# South Gloucestershire Council

## PLANNING APPLICATION CONSULTATION RESPONSE

<b>Memorandum to: (Case Officer)</b>	Char Eyre-Walker, Principal Planning Officer
<b>From:</b>	Heather Cameron, Public Open Space Officer
<b>Email:</b>	heather.cameron@southglos.gov.uk
<b>Date:</b>	<del>22/04/22</del> 24/03/23
<b>Planning Application Number:</b>	P22/01300/O
<b>Site Address:</b>	Land At Sodbury Road, Wickwar, South Gloucestershire, GL12 8PG
<b>Description of Development:</b>	Erection of up to 180 dwellings, a local shop and associated infrastructure (Outline) with access to be determined; all other matters reserved
<b>SUMMARY OF POS SECTION 106 REQUESTS</b>	
Off-site POS provision/ enhancement contribution	<b>TBC see table below</b>
Off-site POS maintenance contribution	<b>TBC see table below</b>
On-site POS	<b>TBC</b>
POS inspection fees if private management proposed	<b>£63.96 per 100sq.m.plus £615.90 core service fee</b>

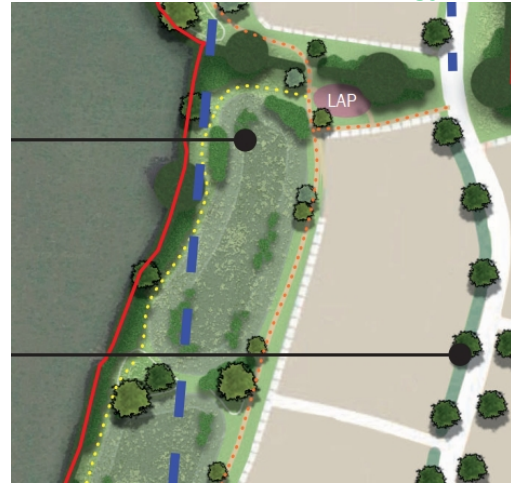
DAS illustrations on p65 show joggers, cyclists, children playing football, elderly people walking, etc. Given the constraints the SWI would introduce to the usability of the open spaces, I fail to understand how these activities could be easily introduced given the current layout:

No pedestrian routes are shown throughout the POS other than a path linking the separate sections of the development. In order to make the POS usable for the community, I would suggest a sealed surfaced route should be provided, which would be inclusive and not compromised by wet weather and erosion; something such as a tinted tarmac. Seating and bins should also be provided to encourage use of the POS. The site design is not currently conducive to circular walking around the open spaces due to the space taken up by the basin and swale effectively creating barriers to usability. Some of the perimeter open space is less than 3m in width. Given the presence of boundary hedges, effective and usable width by people would be even narrower, with no space for pathways. Given that many of the perimeter roads are shown as private, and the narrow width of the open space, maintenance access would be very limited and not be able to be carried out efficiently. Space for additional planting is limited.

### Snip of Landscape Strategy

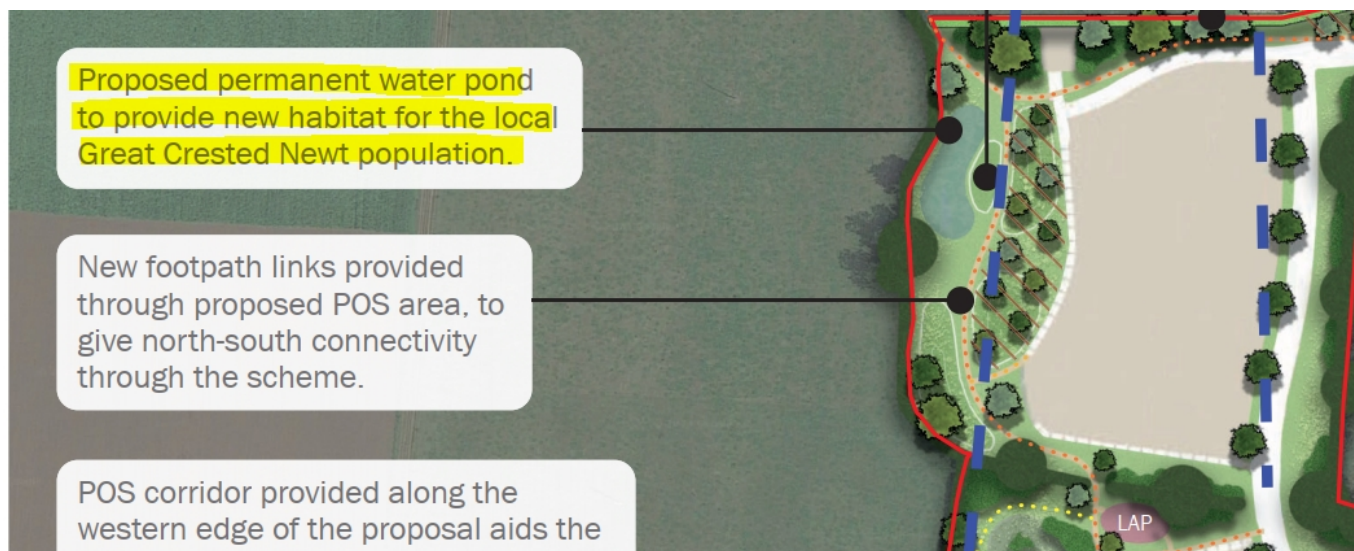
The “opportunity for mown informal footpaths” are shown running along the western boundary of two of the drainage basins. I do not believe that there would be adequate space along this perimeter open space to accommodate boundary hedges, enhanced planting, drainage basin maintenance and pathways (no matter what surface they are).

Sufficient tanker access into the pumping station by tanker would be needed; it would appear from the plans that adequate access has not yet been considered.

## 1.2 Site Location and Description

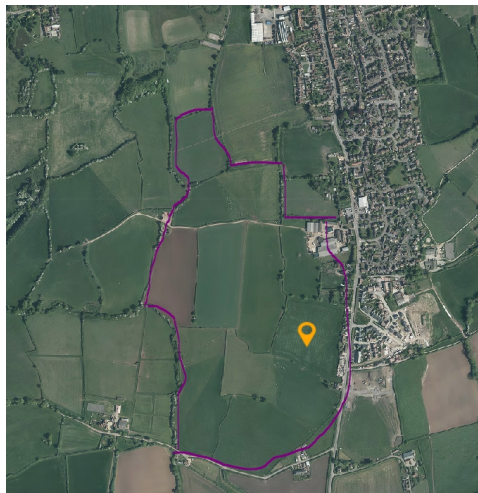
Outdoor Sports Facilities - None are proposed and no justification as to why off-site provision creates a more acceptable proposal than on-site. It is clear from the application documentation that although the current application is for 7.89ha, the applicant intends to apply for permission on 38ha in total. The current application is therefore only 20% of that land. I consider that they should be providing entirely for their own needs within this application or within their land. I consider it unreasonable for them to abdicate their responsibility to deliver to cater for the needs of their residents and to expect the Council/Parish Council to deliver on their behalf, as there is probably a limit to what can be delivered/improved at local facilities. If permission were to be granted for the outline application, I feel it should be on the basis of four options.

I am not sure how feasible this is, and I know we can only look at the current outline application but the documentation is clear:

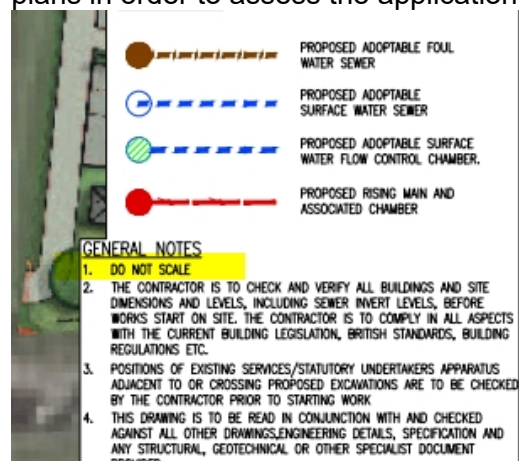
With reference to the following extract from the DAS, please note that the allotment plots should be for renting to residents of the development only, as there is not a massive amount over the minimum policy requirement.

The applicant must demonstrate that the elevated zinc levels will not have a detrimental impact upon plant growth anywhere on site but this is particularly important for the proposed allotment area. It is not acceptable to simply state "Consultation with a landscape architect is recommended", "Discussion with a landscape architect is required to assess the significance of the raised zinc concentrations identified" and "A landscape architect should be consulted to determine suitable plants for the encountered soil". We need to know whether fruit and vegetable production would be affected or whether the levels of zinc in the plants would be harmful to human health. I recommend that Environmental Protection are specifically consulted on this matter once additional information has been provided. Nothing has been submitted to elaborate on this matter and I can see no comment from Environmental Protection.

Figure 34: Illustrative Cross Section of Attenuation Features within Open Space

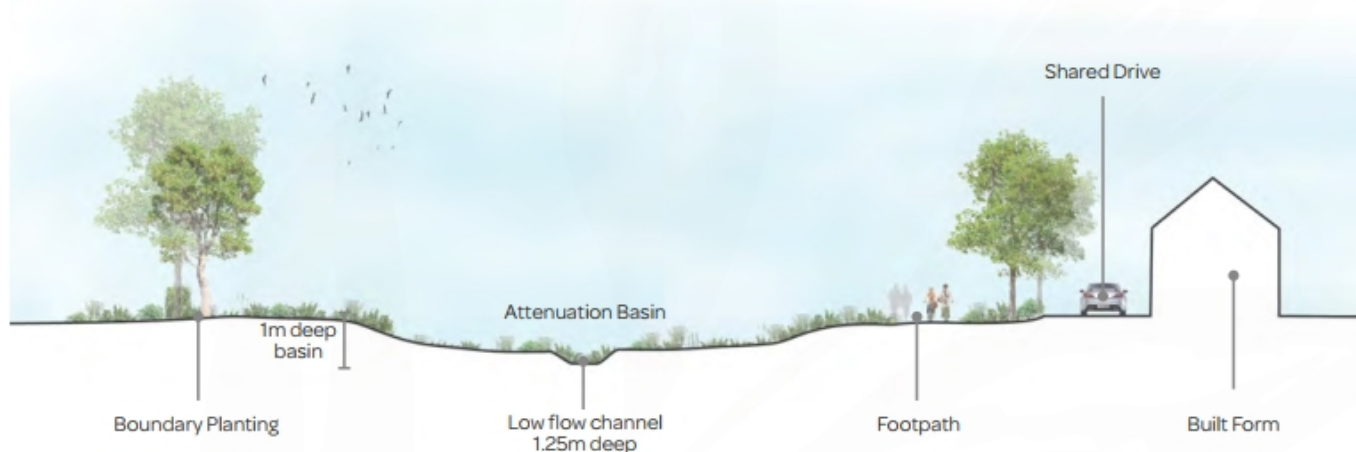
The illustrative cross-section of the attenuation basin in the DAS does not seem to match the scale of the basin in the drainage strategy where little usable space is left around the perimeter: Snips replaced with amended illustrative cross-section in DAS rev B and Drainage Strategy Sheet 1 rev P05.  
**Snip of page 90 DAS rev B**

Our experience is that illustrative proposals are always almost over-optimistic, and that detailed designs require a greater land take in order to attenuate the volume required; consequently usable POS becomes reduced. **My comments are still relevant despite amendments to the FRA.**
